Comment Letters

Comment Letter Index

Greg Nudd
Air Program Manager
Bay Area Air Quality Management District
939 Ellis Street
San Francisco, California 94109

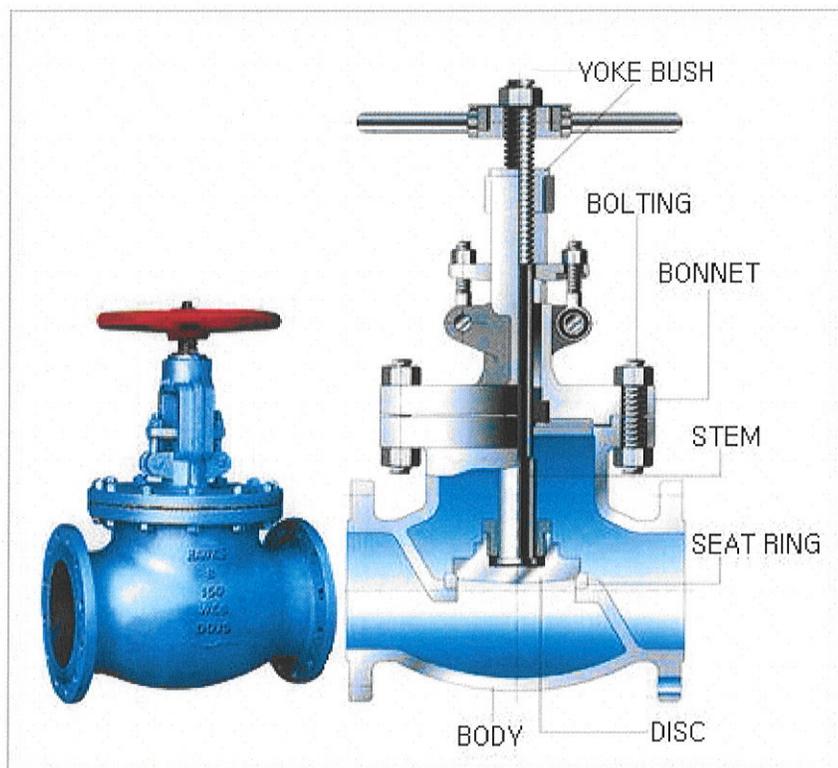
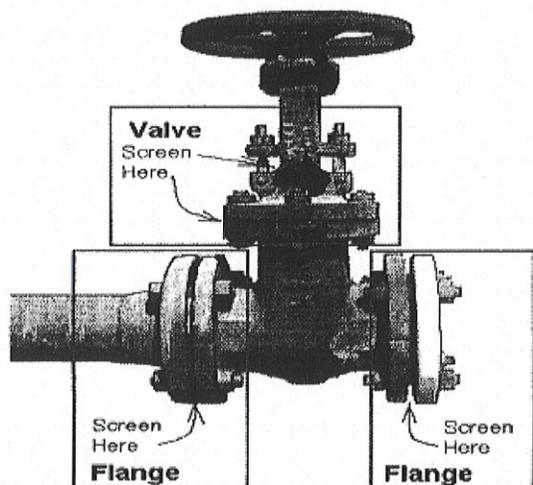
bonnet flange.” The bonnet flange is on the vertical portion of the valve (shown as the flange with the comment of “Screen Here” for a valve in the CAPCOA document) and is considered as an integral part of the valve, not a separate component. To count this as a separate connection would confuse the component counts.

Figures, 1, 2, and 3
(see below)

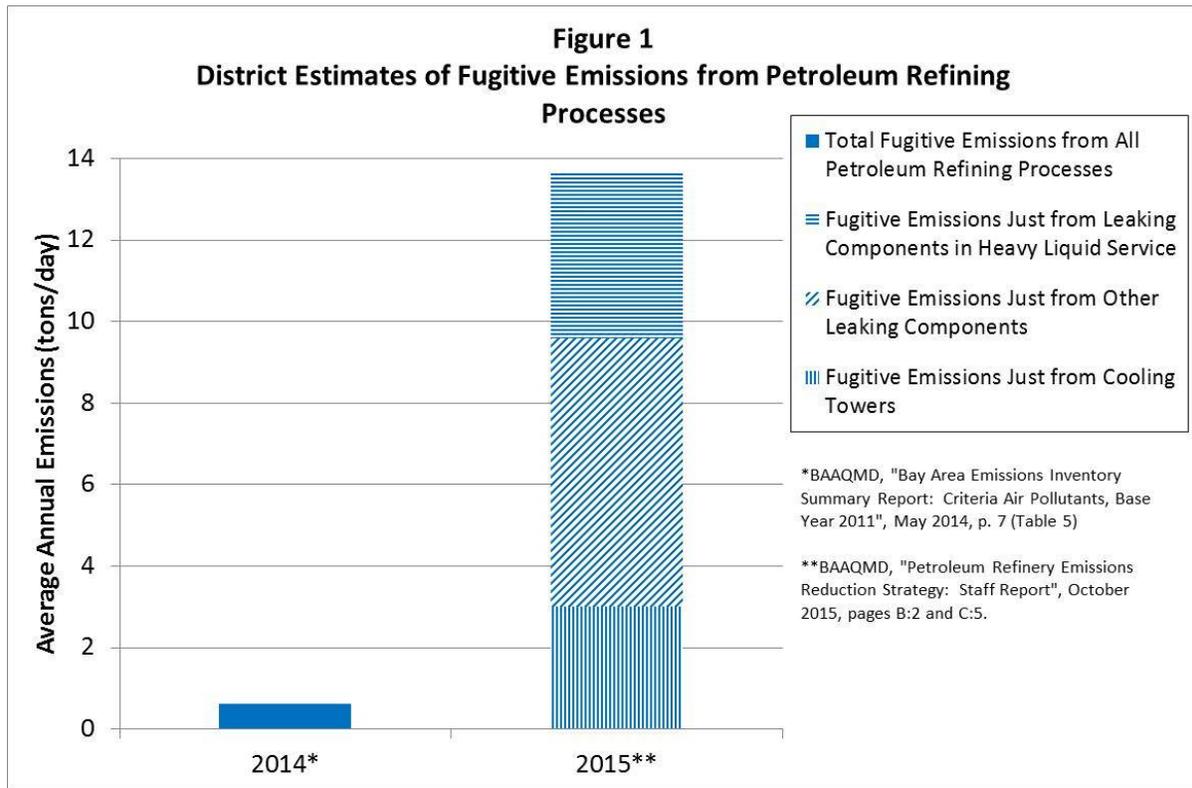
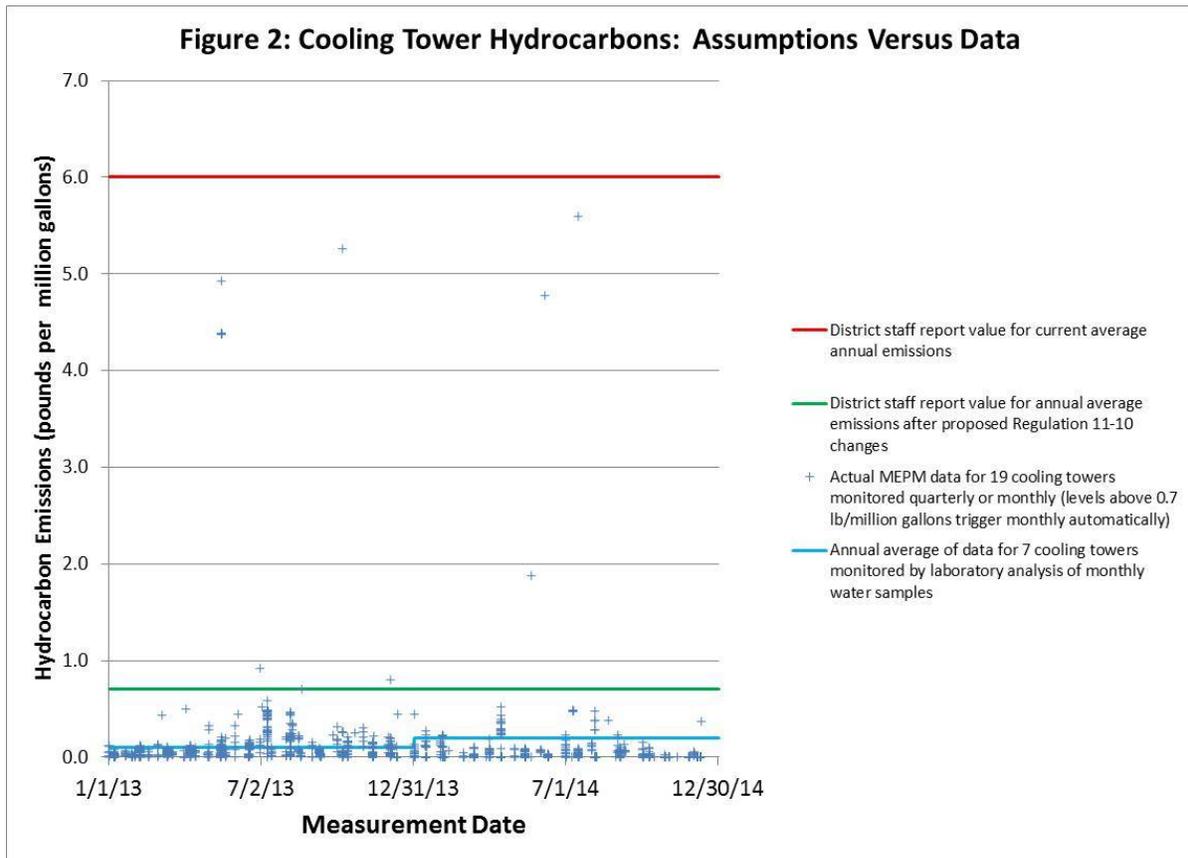
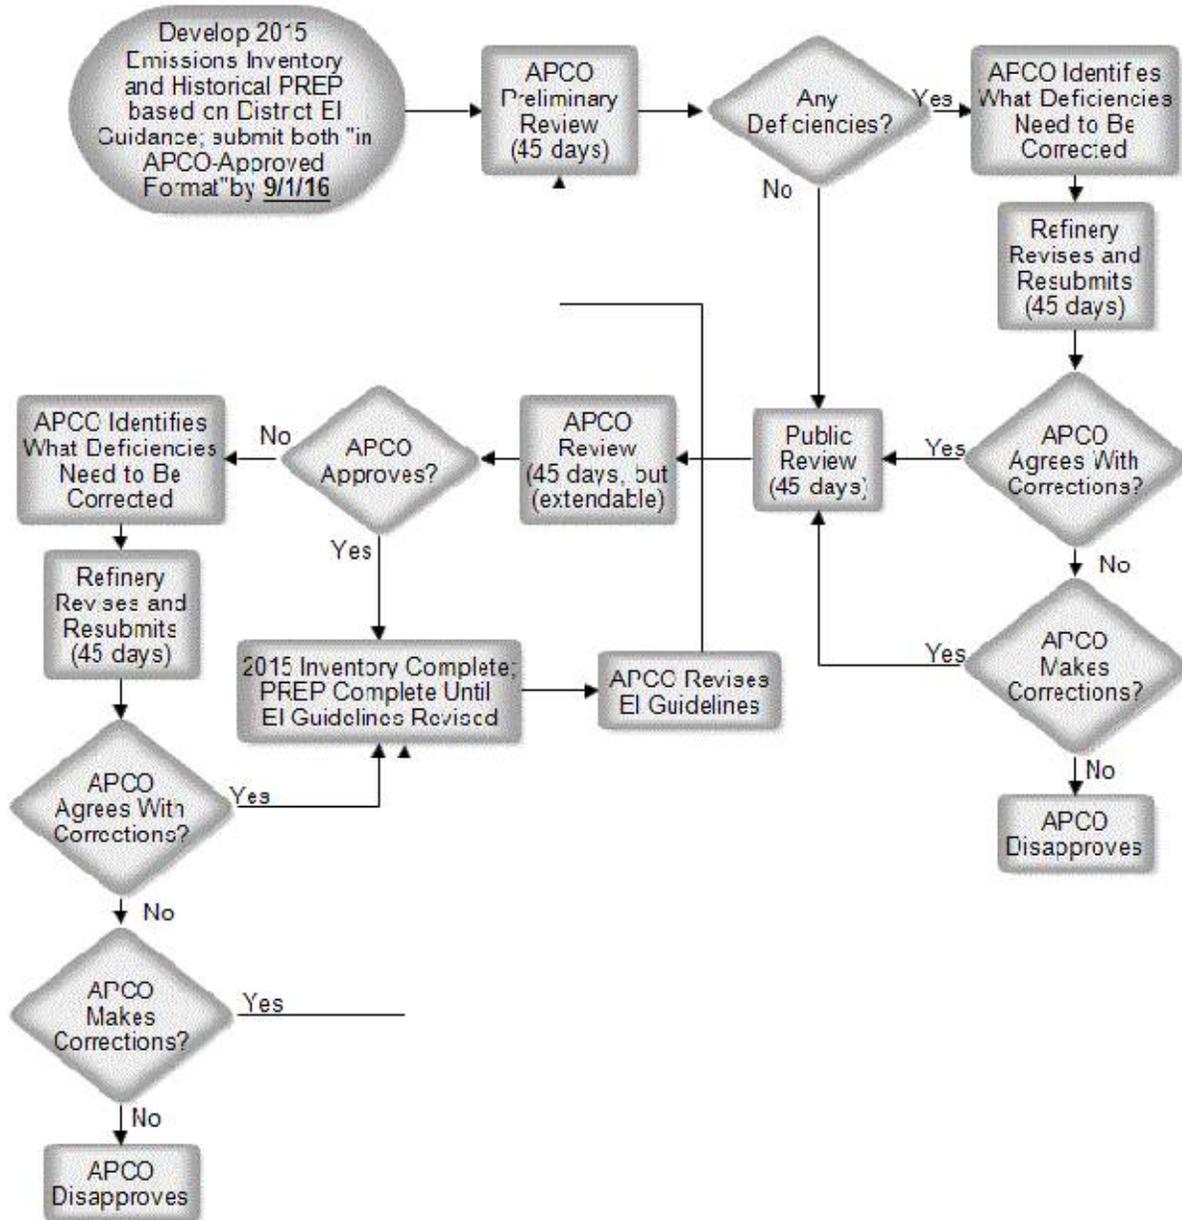
The data in Figure 1 shows that District staff are now identifying emissions from fugitive leaks alone as being higher than the 4.2 tons per day that District staff identified in 2014 for all refinery processes combined),¹¹

In recent years, District staff have forced refineries to accept their estimation of emissions, and pay the corresponding fees, or risk not receiving a permit renewal. Both EPA guidance and District guidance identify the preferred emissions inventory method as being based on sampling data collected using EPA-specified methods. Thousands of samples have been analyzed by the five refineries using this method, and Figure 2 shows that the emissions are far lower than what the District estimated.

Figure 1

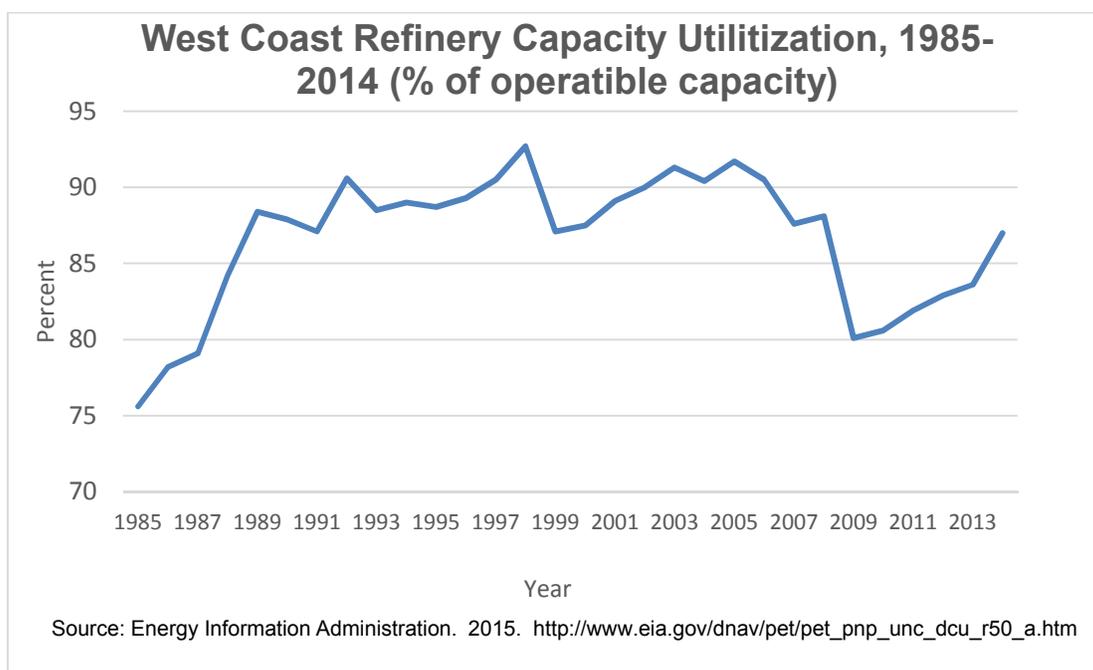
gauging significance of impact. Whether the estimated profits bear any resemblance to actual profits is unknown and entirely untested, yet the entire significance test depends the initial profitability figure. It would be useful to know how those profit estimates compare with the firm-level profit data given annual reports for each of the five companies that own the refineries. (Recognizing that each firm owns many refineries and that each is likely to have a unique profit rate.)

Furthermore, the data are estimated a single point in time, despite the fact that we know refinery utilization and profitably have a strong cycle. We have shown the recent history of refinery utilization in Figure 1 below. Whereas ADE selected a fixed rate, consistent with formulating a point estimate of profitability (87 percent), it is evident that West Coast refineries have a history of volatile utilization. If we had selected to use only data since the trough of the last recession, we would cut four percentage points of the utilization rate, cutting the ADE profitability estimate significantly and bringing the rule-change value much closer to significance.

Figure 2

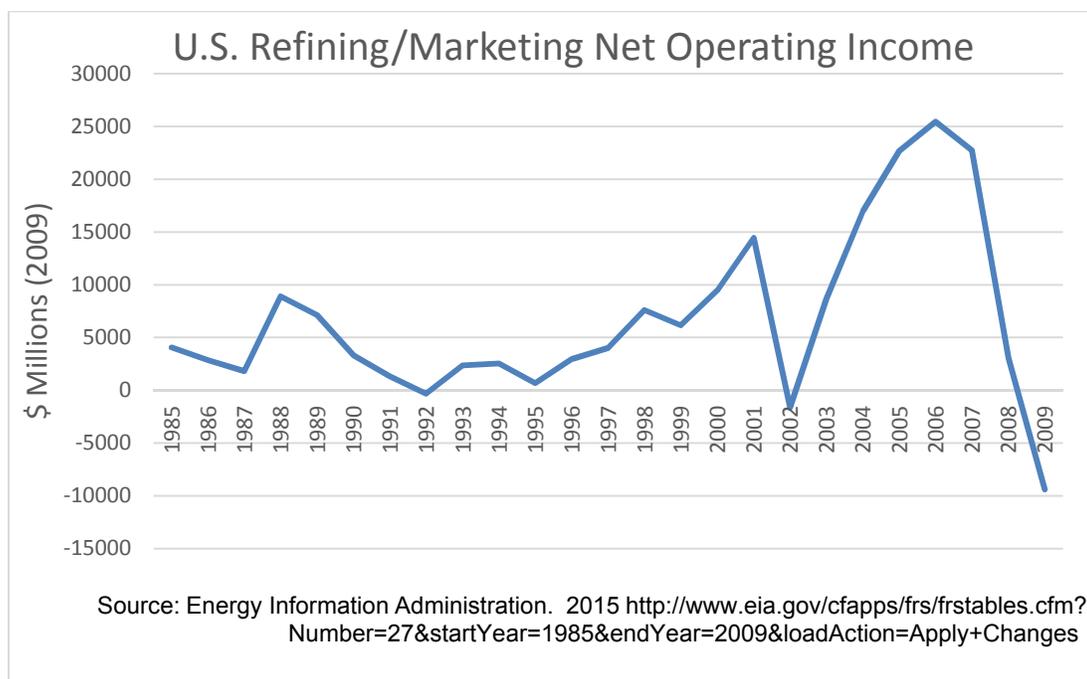
As shown in Figure 2, below, profitability as estimated by the U.S. Department of Energy, Energy Information Administration, is highly volatile, with the most recent years shown (up to 2009) being negative. Clearly, the significance test for impact should be made using data that are cyclically neutral so that we can establish the long-run profitability first, and then determine how proposed regulations affect that, not a single point in time estimate.⁹⁴
